May 2nd, 2022
Project No. C206-21

**RE: Final Site Plan Review – Town Memo Revisions
Terra Cotta Pasta Company (Tax Map 3, Lot 1)
52 State Road, Kittery, Maine**

**RE: Site Plan Review Application – Peer Review Revisions
Terra Cotta Pasta Company (Tax Map 3, Lot 1)
52 State Road, Kittery, Maine**

GRADING & UTILITY PLAN
TERRA COTTA EXPANSION
STATE ROAD, KITTEERY, MAINE

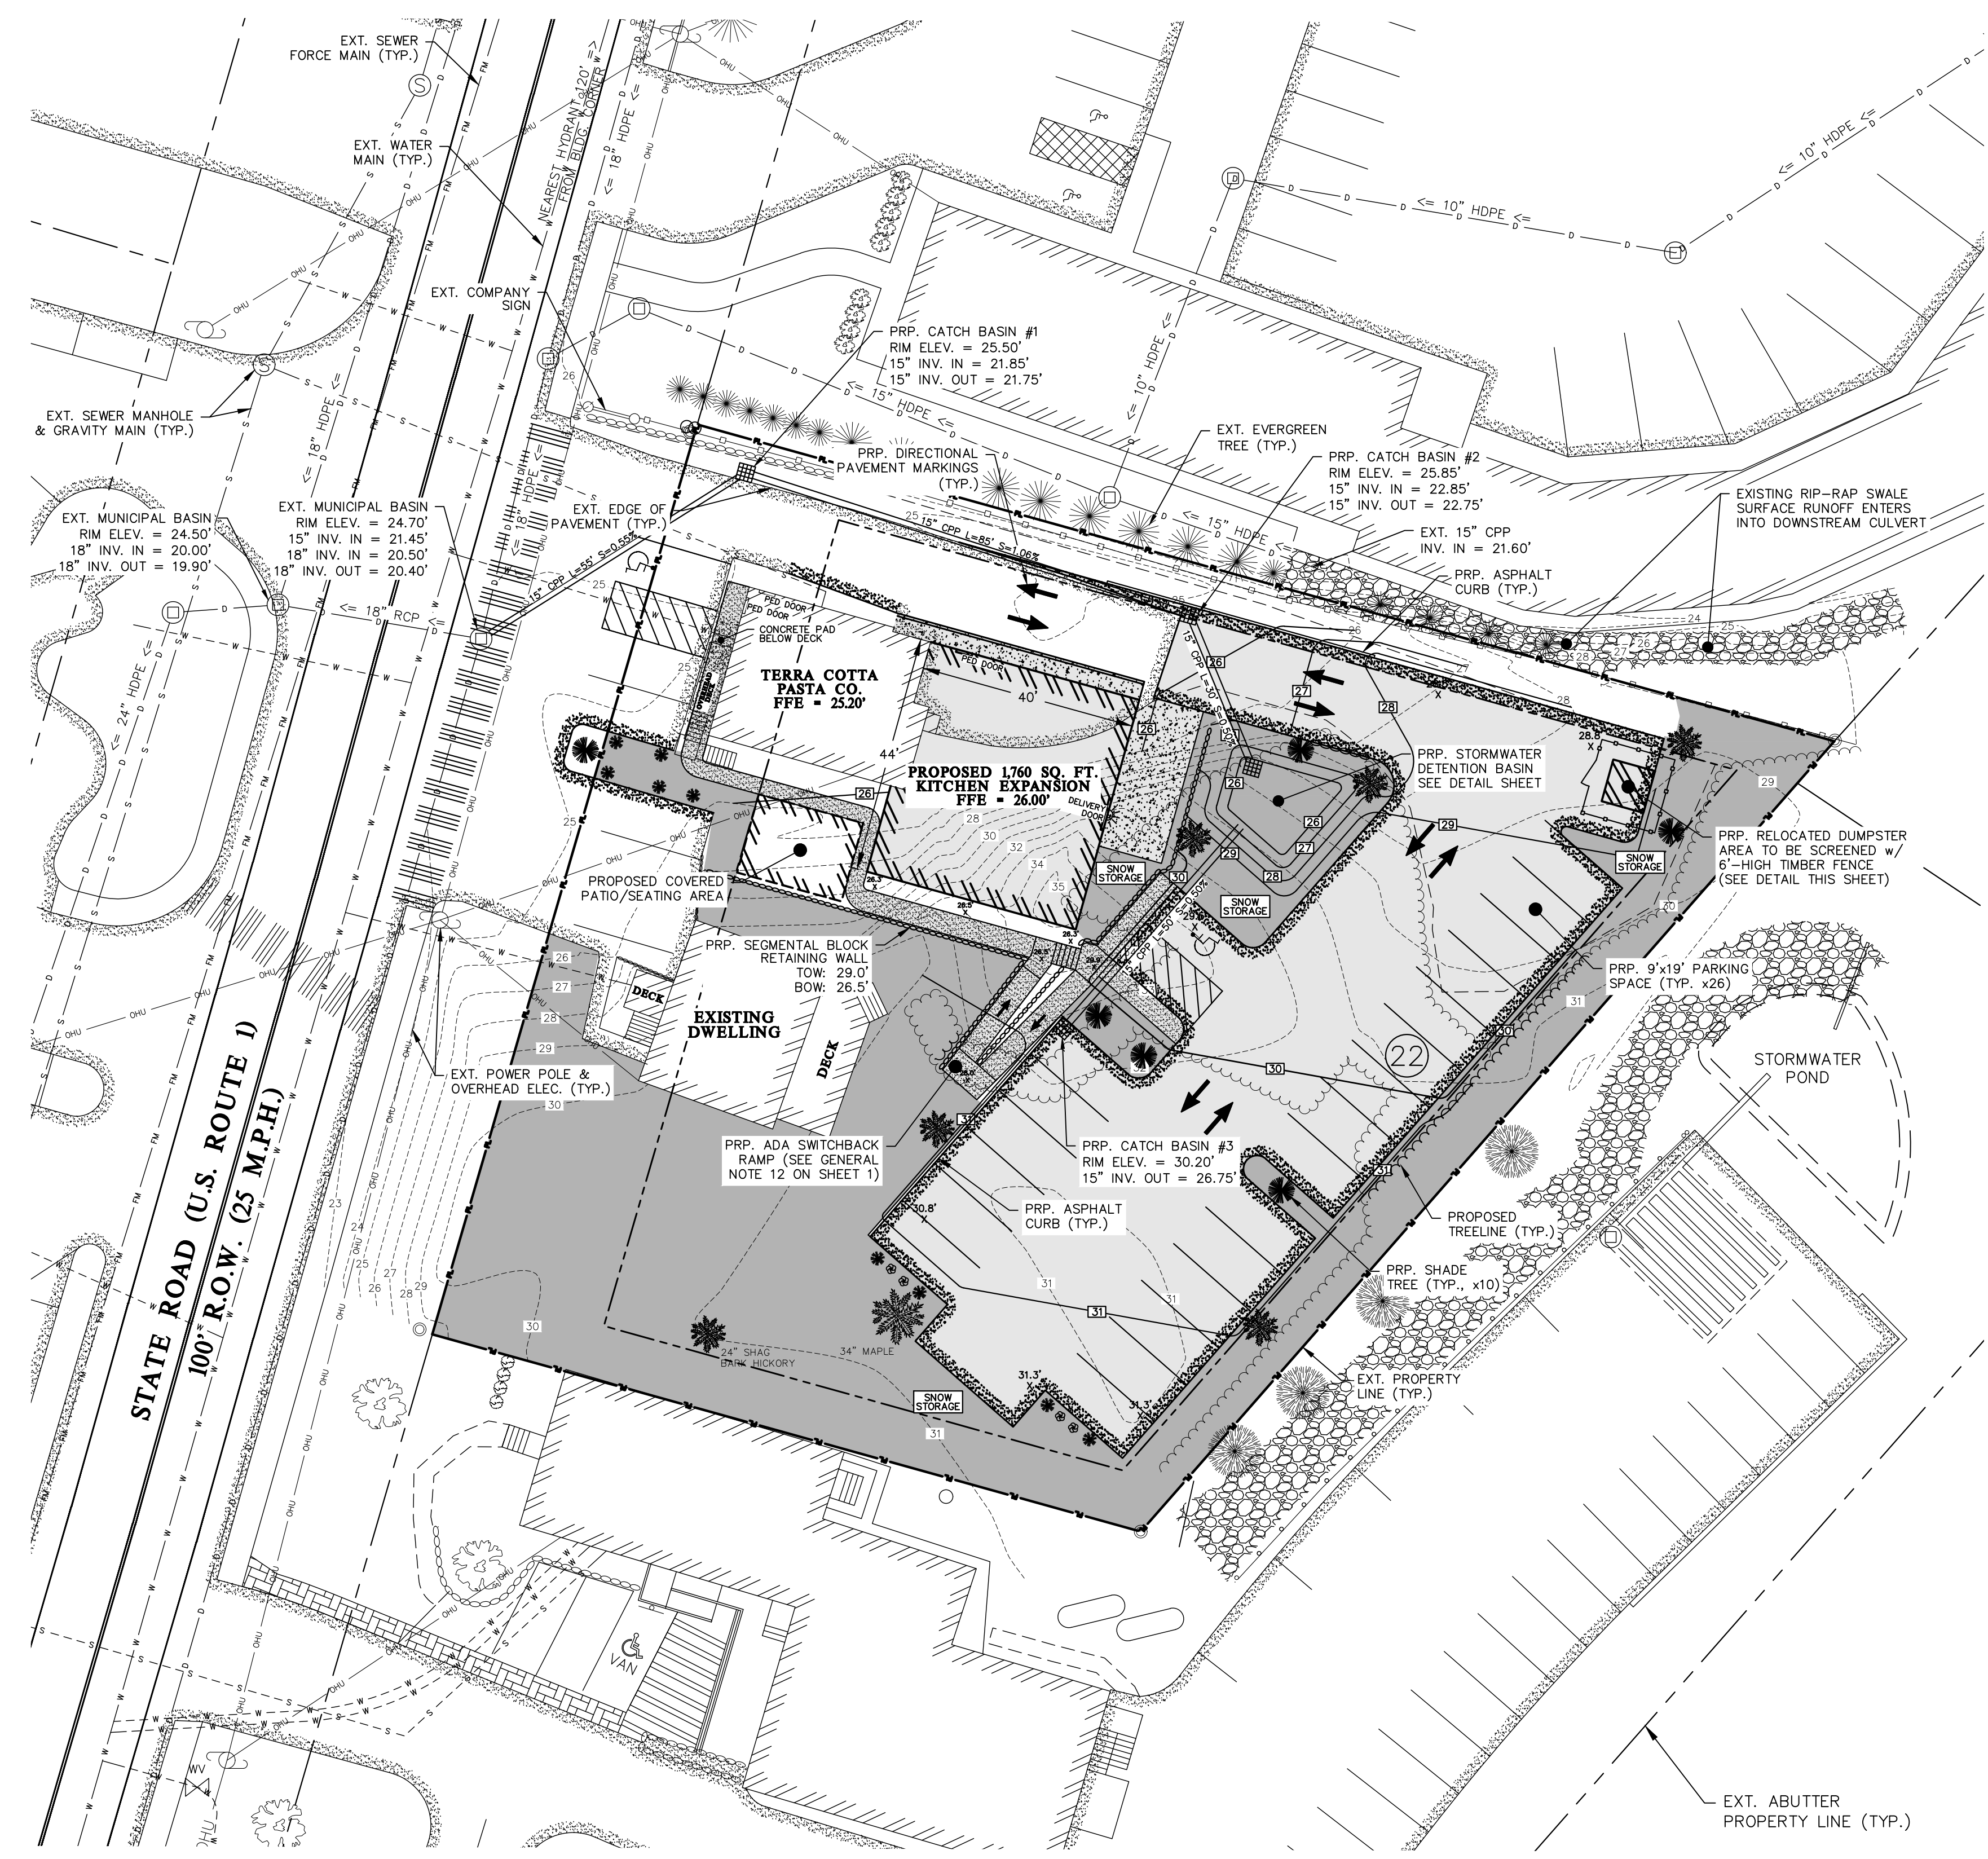
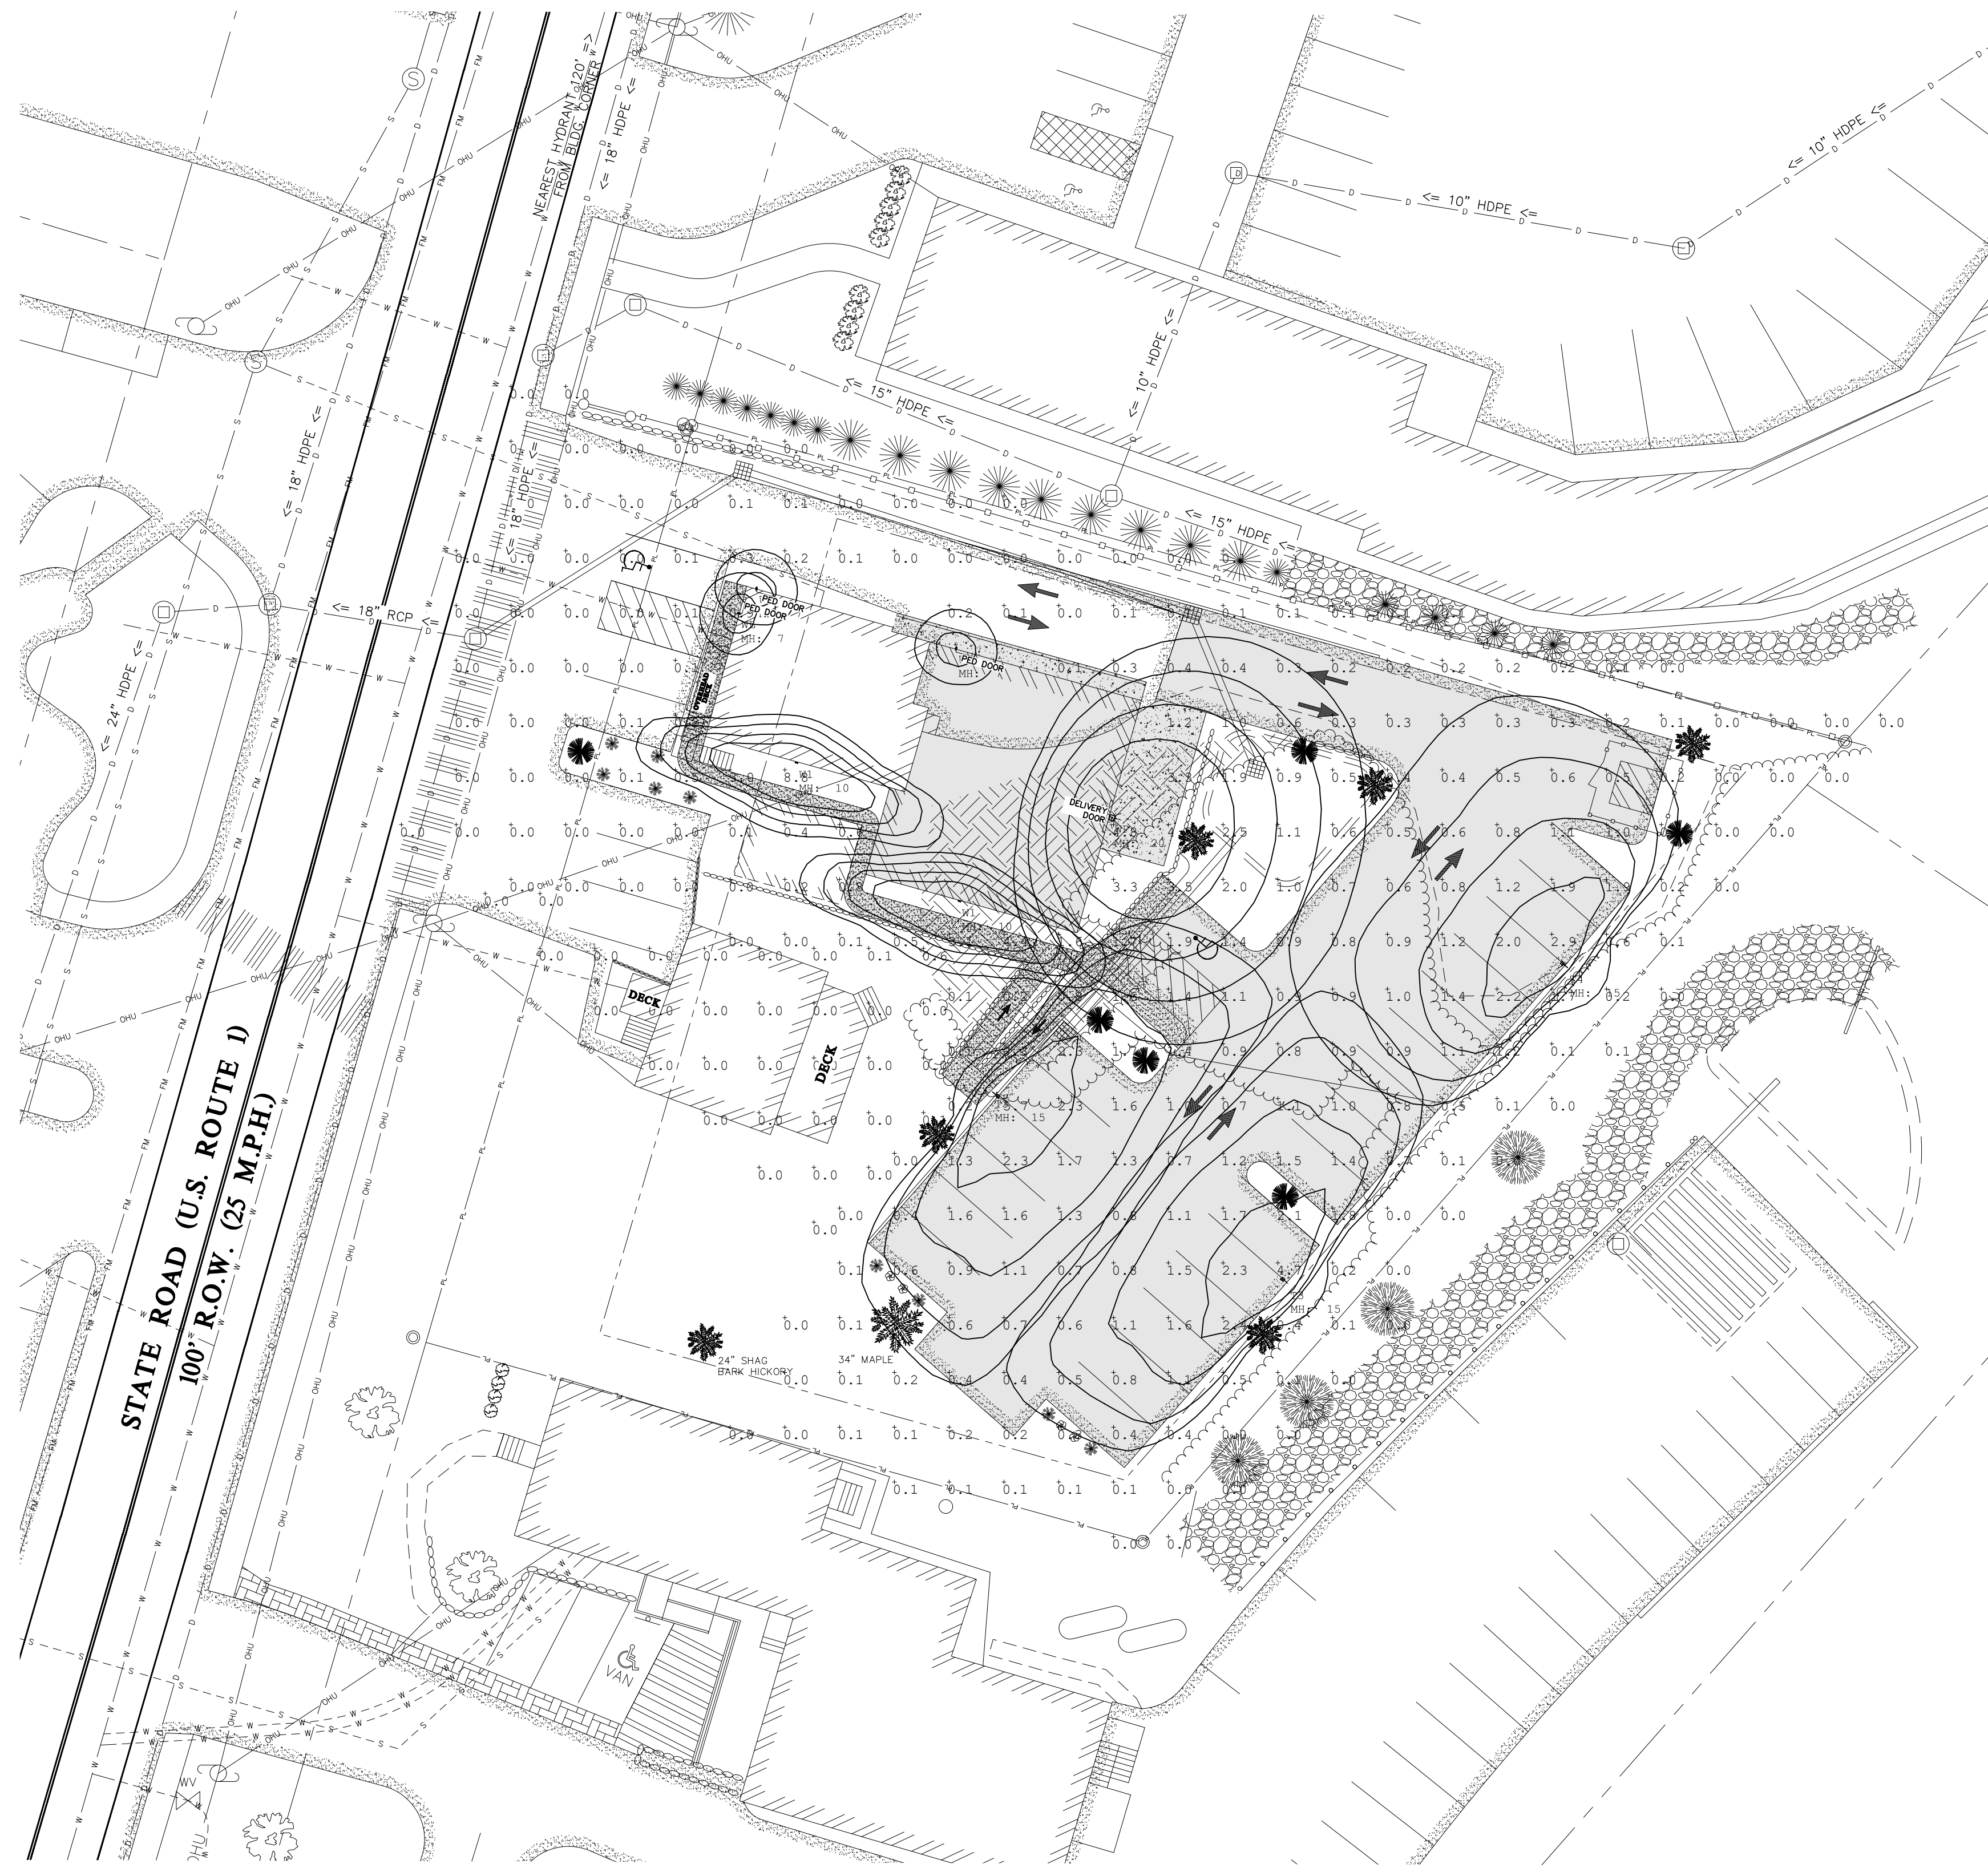
- The Grading & Utility Plan (Plan Set Sheet 3) provides a landscaping legend which includes the species, quantity, and size of all plantings to be included with the proposed development. Additionally, Grading & Utility Note #4 on Sheet 3 has been revised to provide clarity to the transparent hatch that represents the landscaped area of the subject parcel. General Note #9 on Sheet 1 has been revised to reference this note on Sheet 3.

- Grading & Utility Note #3 on Sheet 3 has been revised to state that on-site maintenance of drainage features that tie in downstream to the Town of Kittery MS4 system shall be the responsibility of the property owner.
- Sheet 3 has been revised to include the requested lengths, materials, and slopes for all proposed pipe installations.

- Callouts on Sheet 3 have been revised and added to properly include all rim elevations and invert/outlet information for all proposed catch basins and all relevant existing MS4 basins which are being affected by the proposed development.

PHOTOMETRIC PLAN
TERRA COTTA EXPANSION
STATE ROAD, KITTEERY, MAINE

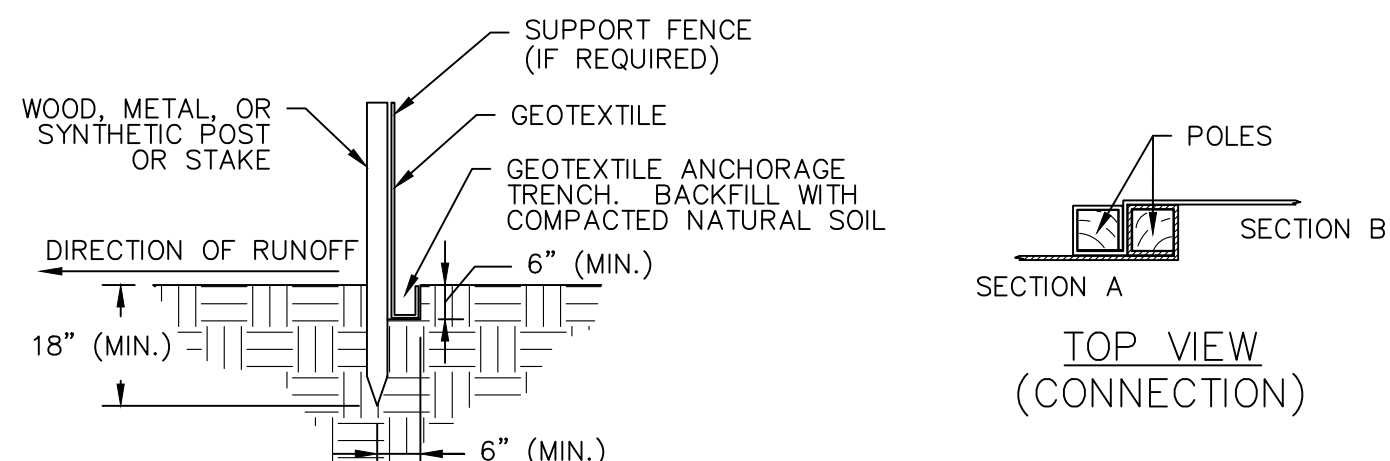
- Sheet 5 (Photometric Plan) has been revised to have an increased contrast between the lighting elements and other project linework that isn't essential for this sheet. A 'Photometric Plan Notes' segment has been added to the bottom of Sheet 5 which denotes the existing and proposed lighting depicted in this photometric plan. Lastly, all relevant lighting specification sheets for all proposed units has been attached to demonstrate compliance with Dark Sky optics.
